BRE Client Report

Review of daylight and sunlight assessment for Brighton Gasworks

Prepared for: Brighton & Hove City Council
Date: 13 January 2022
Report Number: P122214-1000 Issue: 1

Figure 3: Sunlight results for proposed gardens and open spaces. Yellow areas (surrounded by blue or pink lines) show areas able to receive at least two hours of sunlight on 21 March. Grey areas would receive less than two hours. North is to the left of the picture.

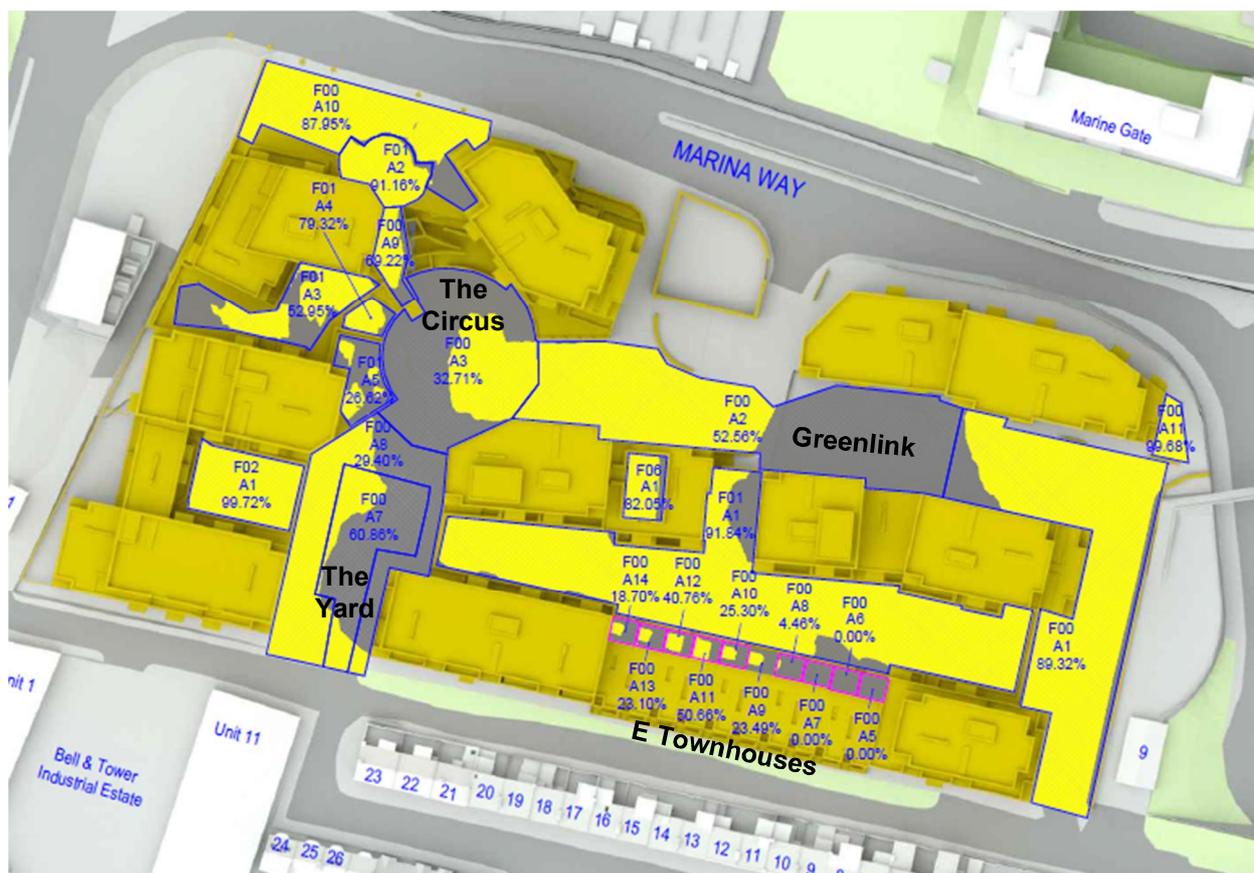
- 4.4.3 The area to the east of the townhouses and Blocks E1 and E4 would meet the BRE guidelines and be well sunlit. As would the space to the south of the site.

- 4.4.4 The “Greenlink” area would just meet the BRE guidelines as just over 52% of the analysed area would be able to receive at least two hours of sunlight on 21 March. The northern section would be well sunlit, the southern section less well sunlit.

- 4.4.5 “The Circus” would be below the BRE guidelines and would be classed as inadequately sunlit.
- 4.4.6 “The Yard” has been analysed as two separate areas (the labelled results in the report and Figure 3 above appear to be the wrong way round). The northern area would be well sunlit. The central and southern areas would not be well sunlit. It appears the central area is to be used for vehicular access; sunlight provision here may be less of an issue.

- 4.4.7 Areas to the north of the site generally meet the BRE guidelines, including the courtyard space in Blocks A and B and the area between Blocks B and C (although this is marginal to the guideline). A first floor commercial terrace (labelled as F01 A5 in the report and Figure 3) would be below the guideline.

- 4.4.8 The gardens to the townhouses would be poorly sunlit. Only one of the ten gardens would meet the BRE guidelines, and this only just meets the 50% target. Three of the gardens (shown as A5

to A7 in Figure 3) would have none of their area able to receive at least two hours of sunlight on 21 March.
